Matthew C. Murphy, PE, CWI, PE
Stonewall Structural Engineering, PLLC
9203 Baileywick Rd. #200
Raleigh, NC 27615
(919)407-8663

Re: Review of Proposed 1st Floor Framing Repairs — 678 Raven Rock Road, Lillington, NC 27546

Detail 1 – IntelliJack Specifications

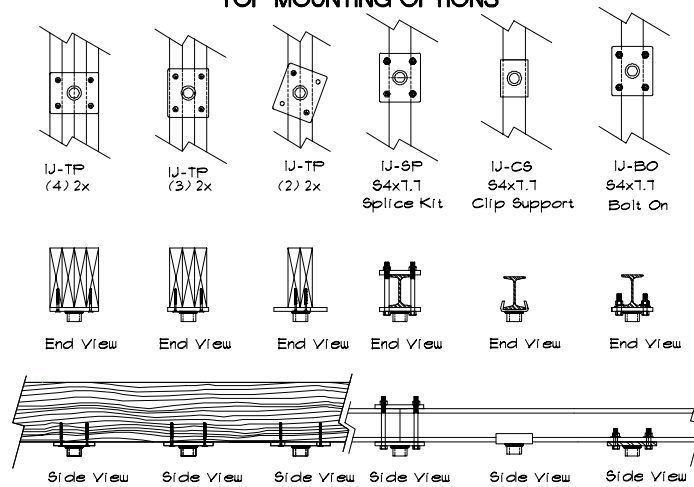
1. Remove and replace the above-noted deteriorated girder using full depth treated (3) 2x #2 SYP material with continuous span between existing masonry girder support piers.
 - a. Reinforce the midspan of the new girder using an IntelliJack support on a well-compacted 18"x18"x18" gravel footing (*See Detail 1*).
2. Reinforce each of the deteriorated joists noted above with an additional full depth ply of 2x #2 Southern Yellow Pine (SYP), fastened to the side of the deteriorated joists using (3) 10d common nails at each end and at 12" on center staggered top and bottom along the lengths of the joists. Sistered material should span continuously between end supports.

First-Floor Framing Repairs		
Tar Heel Basement Systems 678 Raven Rock Road Lillington, NC 27546		
SCALE:	NTS	JOB #:
DRAWN BY:	NFP	25-1295
DATE:	2025.02.21	SHEET #: SK1

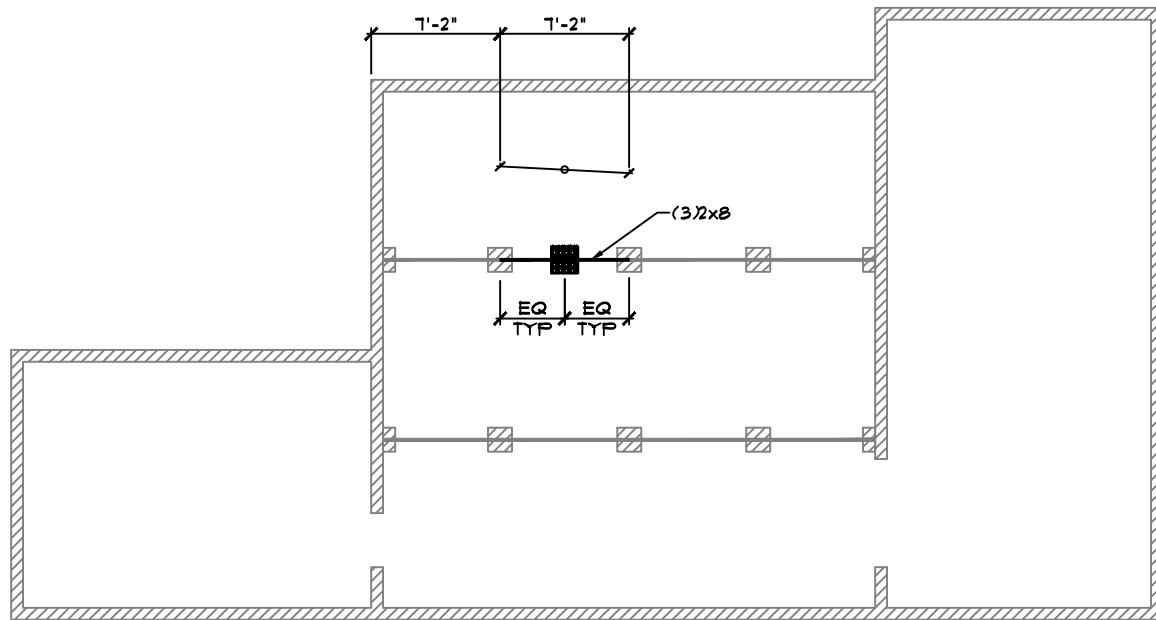
- INDICATES INTELLIJACK SUPPORT ON WELL-COMPACTED 18"x18"x18" GRAVEL FTG PER REPORT & ATTACHED DETAILS
- INDICATES (N) GIRDER PER REPORT
- ⊖ INDICATES PORTION OF (E) JOISTS AT 16" O.C. TO BE REINFORCED PER REPORT
